## **Further comment by the Orakei Local Board pursuant to section 15(2) Local Government Auckland Council Act 2009 relating to 1-3 Purewa Road, Meadowbank**

McConnell Developments Limited (the “applicant”) seeks resource consent to establish a new 24-unit residential apartment building, comprising a combination of 1, 2, and 3 bedroom dwellings, with 31 carparks (contained entirely within a basement level). All existing structures within the subject site will be demolished.

**Figure 5:** Proposed wastewater and stormwater network connections (Source: Engineering Report, Civilplan Consultants)

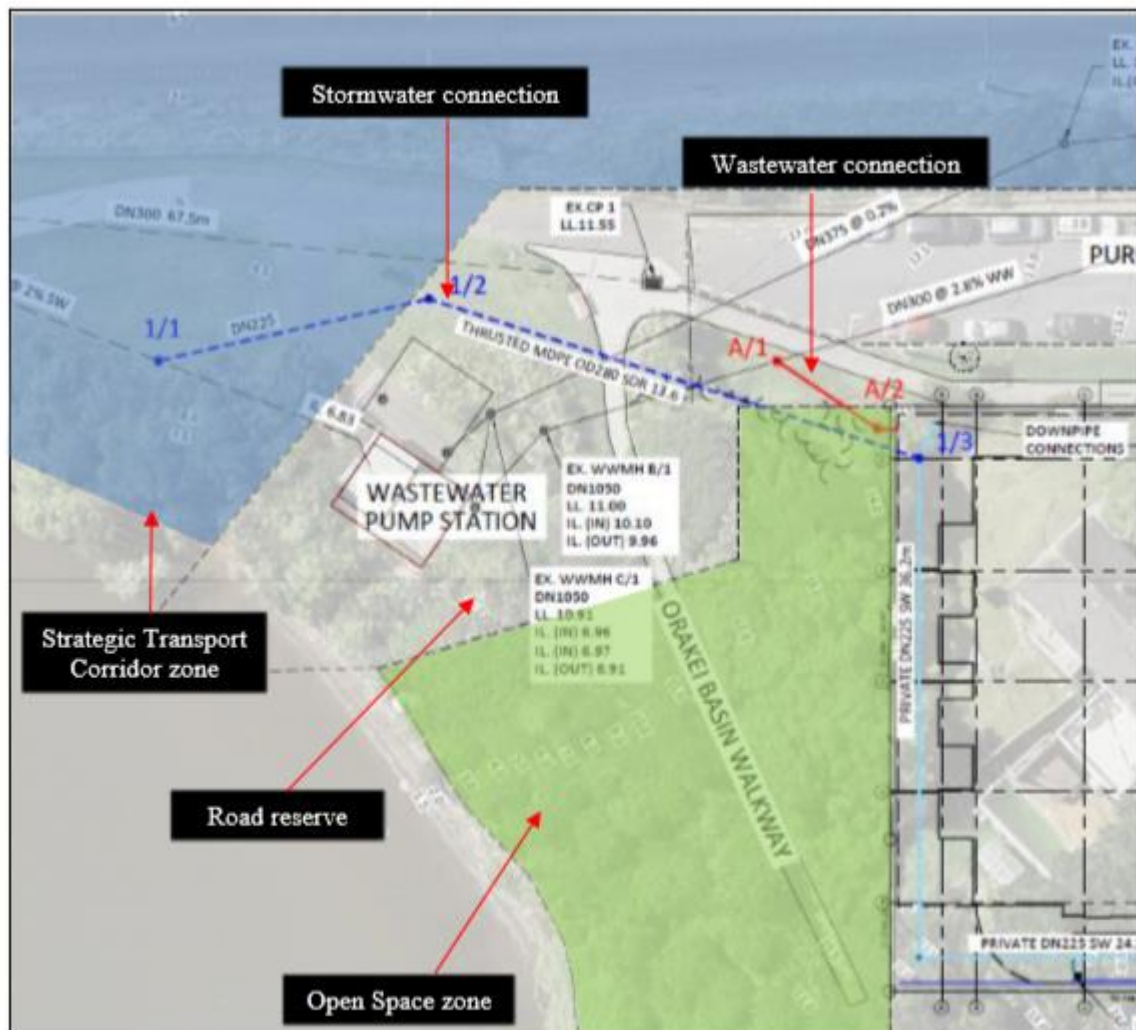
4. This area consistently produces a strong odour due to excess stormwater and waste flows. We understand the pump station can only discharge between 130-140lps which we also understand is currently handled incorrectly by utilising the emergency overflow tanks at the pump station, and this is a probable cause of the “stink issue” that has long existed. Accordingly, we think this application, if granted, will clearly generate more adverse odour and discharge effects.

5. The Board notes members of the nearby local community indicated there could be 50 odd legally established stormwater connections that feed to the wastewater network in the catchment. Council and Watercare personnel mentioned in Ms Lee’s memo are now fully aware of the existence of the legitimate private stormwater connections to the Purewa wastewater network also.

6. A rough rule of thumb calculation is; a small 100m<sup>2</sup> house roof area requires the same flow capacity as 4 households of wastewater. So, if the 50 houses with stormwater connections and around 200 with sewage connections to the wastewater network, then close to 80% of the overall capacity of the network needs to be kept in reserve for when we get heavy rain. Otherwise part of the combined sewage and rainfall ends up in the surrounding streams and Basin waterways.

9. The Board does not support recommending placing a substantial amount of new stormwater runoff from the development into a pipe designed as an emergency overflow pipe for the sewage pump station. If this pipe is utilised for stormwater, and a pump station failure is most likely when we get heavy rain because this is when it is working hardest, then the potential adverse effects are considerably more than minor.

10. The Board understands there is no calculation that properly considers the road runoff + New Stormwater from 1-3 Purewa + 160lps agreed requirement from the pump station. But given the pump station is just above the Orakei Basin water level and the overflow outlet is well above the high tide level of the Pourewa stream, we are concerned the pipe may not have the fall and diameter large enough to cope with the additional effects generated by this application.
